**BEFORE THE PUBLIC UTILITIES COMMISSION  
OF THE STATE OF CALIFORNIA**

Rulemaking 16-02-007  
(Filed February 11, 2016)

**JOINT COMMENTS OF THE BAY AREA MUNICIPAL TRANSMISSION GROUP  
AND THE CITY AND COUNTY OF SAN FRANCISCO IN RESPONSE TO  
ADMINISTRATIVE LAW JUDGE'S RULING SEEKING COMMENT ON THE  
PROPOSED REFERENCE SYSTEM PLAN AND RELATED COMMISSION POLICY  
ACTIONS**

**Figure 1: Selected Resources (MW) under 42MMT Reference Case and 42MMT No Tax Credits Sensitivity Case for years 2018, 2022, 2026 and 2030.**

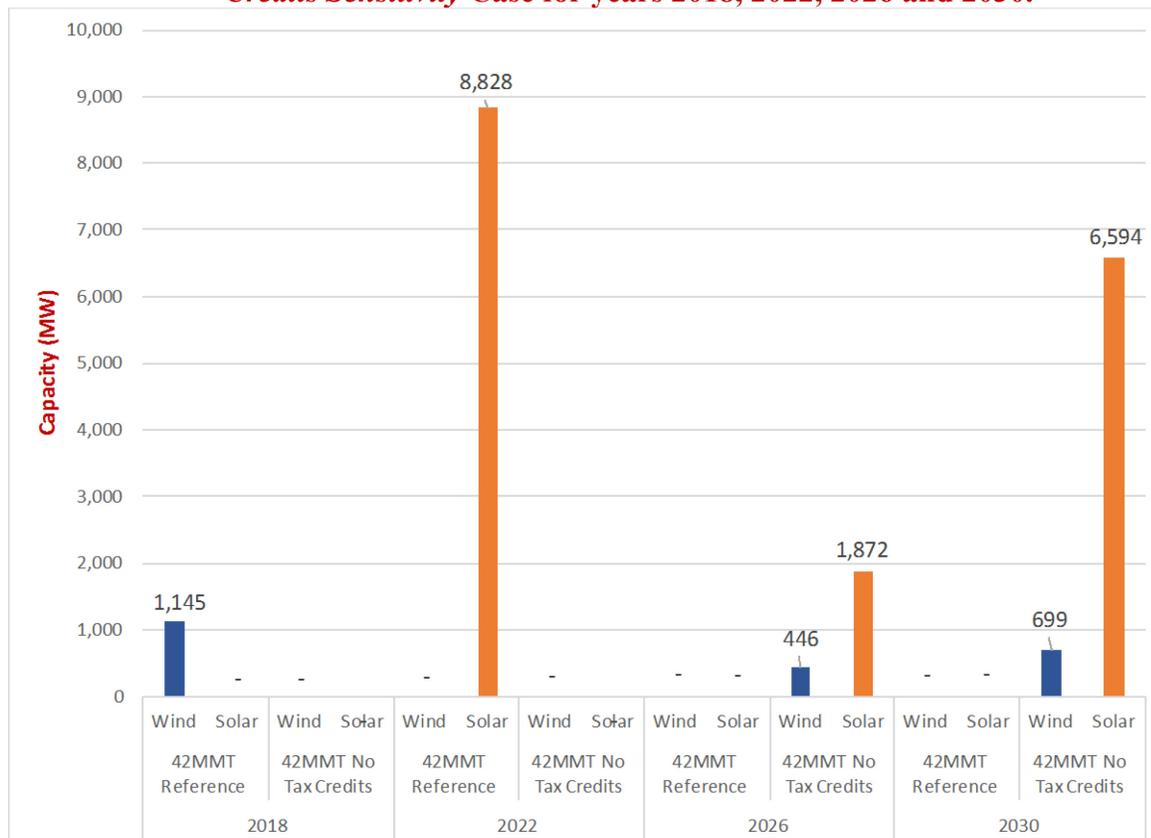
As shown in Figure 1, in the PRSP RESOLVE selects the renewable resources almost a decade early, i.e., in 2018 instead of in 2026 and 2030 for wind and in 2022 instead of 2026 and 2030 for solar to take advantage of the expiring tax credits. The data included in Figure 1 demonstrates that you would need to procure the solar resources in 2026 and 2030 to meet the State’s GHG and RPS goals, however RESOLVE recommends procuring those resources in 2022 to take advantage of the expiring ITCs (as shown in the *42MMT Reference Case*).

However, the implication of procuring the wind and solar resources early in the *42MMT Reference Case* is ***much greater*** New Renewables Fixed Costs in the years 2018, 2022 and 2026. Similarly, the early procurement of renewable resources necessitates additional costs associated with new storage and balancing resources in these years. These increases in costs are compensated by the lower operating costs in later years in the *42MMT Reference Case* relative to the *42MMT No Tax Credits Sensitivity Case*.<sup>11</sup> Overall, as shown in Figure 2, the incremental total resource costs (“TRC”) in the *42MMT No Tax Credits Sensitivity Case* is substantially negative in 2018 and 2022<sup>12</sup>, it is as low as \$10M in 2026, and only increases to \$410M in 2030.<sup>13</sup> In other words, the TRC in the early years are significantly lower in the No Tax Credits

**Figure 2: Incremental TRC and its Components under the 42MMT No Tax Credits Sensitivity Case for years 2018, 2022, 2026 and 2030.**

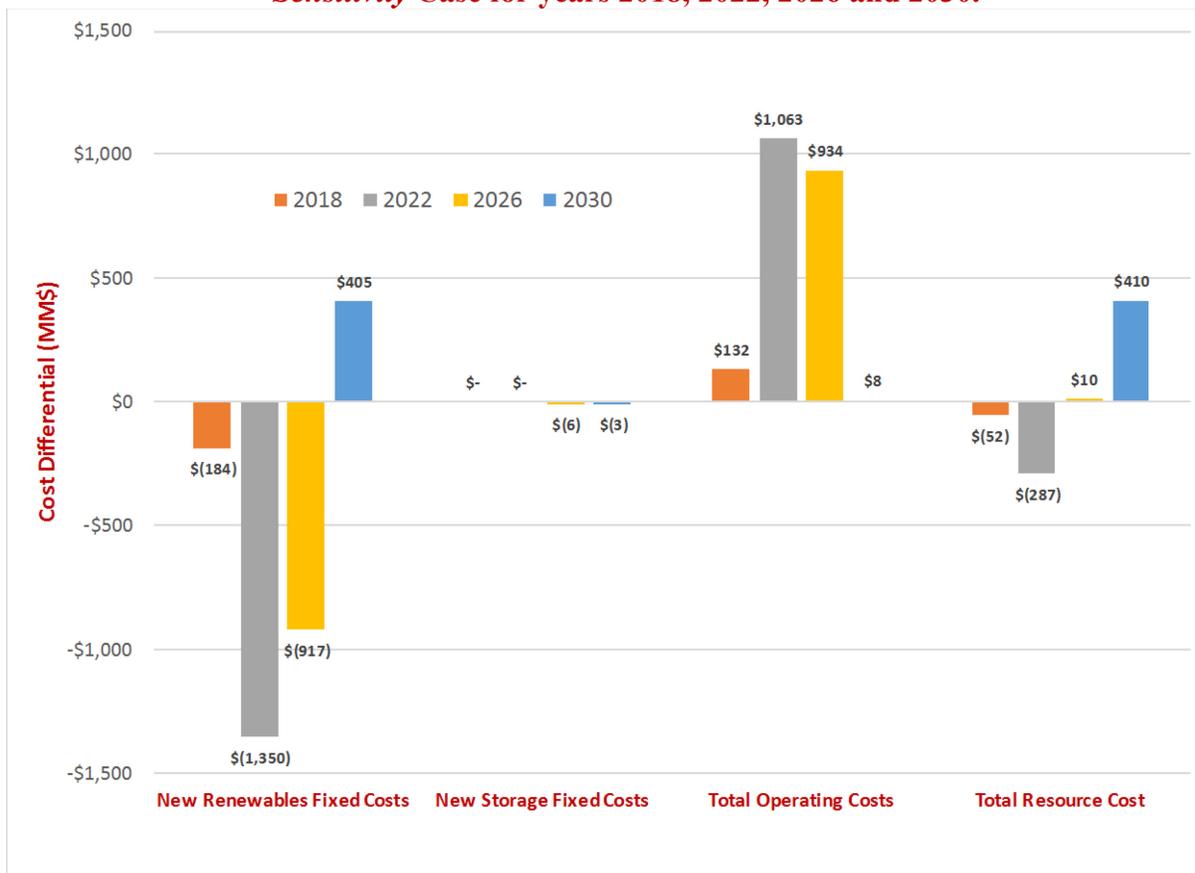
Sensitivity Case relative to the Reference Case that include early procurement. Since the future is uncertain, trading near term costs for benefits far into the future should be considered with great caution.
